Proposal for draft amendments to UN Regulation No. 79 to differentiate the scope of UN Regulation No. 79 and the draft DCAS UN Regulation

Note: The text reproduced below is based on the document ADAS-23-07 as amended at the 23rd ADAS TF session.

Annex 2

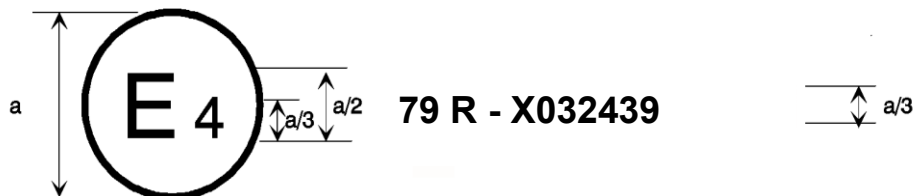
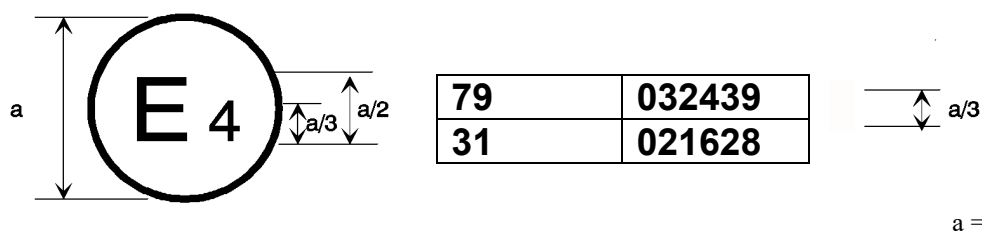
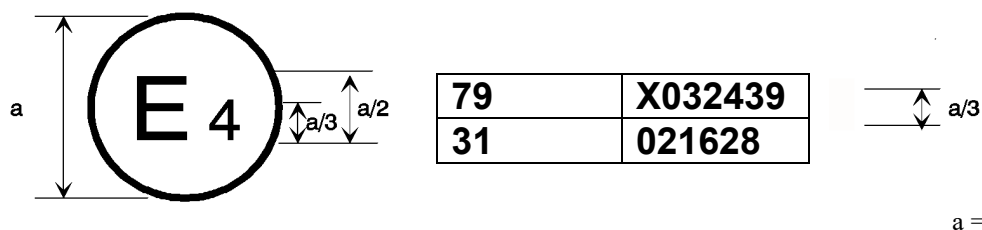
The above approval mark affixed to a vehicle shows that the vehicle type concerned has, with regard to steering equipment, been approved in the Netherlands (E 4) pursuant to UN Regulation No. 79 under approval No. 032439. The letter "X" preceding the approval number indicates that the vehicle is equipped with ACSF or RMF which has been exempted from the requirements of this UN Regulation, and/or that the vehicle is equipped with a steering system which exhibits functionality defined as an ACSF of Category B2, D or E. The approval number indicates that the approval was granted in accordance with the requirements of UN Regulation No. 79 incorporating the 03 series of amendments.

The above approval mark affixed to a vehicle shows that the vehicle type concerned has been approved in the Netherlands (E 4) pursuant to Regulations Nos. 79 and 31.⁴ The letter "X" preceding the approval number pursuant to Regulation No. 79 indicates that the vehicle is equipped with ACSF or RMF which have been exempted from the requirements of this UN Regulation, or that the vehicle is equipped with a steering system which exhibits functionality defined as an ACSF of Category B2, D or E.. The approval numbers indicate that, at the dates when the respective approvals were given, UN Regulation No. 79 incorporating the 03 series of amendments and UN Regulation No. 31 included the 02 series of amendments.

4.4.3. and Annex 2

A new marking provision is added so that approvals to Regulation 79 which have made use of the provisions specifically relating to DCAS and/or R157 can be identified, and therefore Contracting Parties who do not apply either of those regulations can assess whether a Regulation 79 approval is valid in their territory or not.
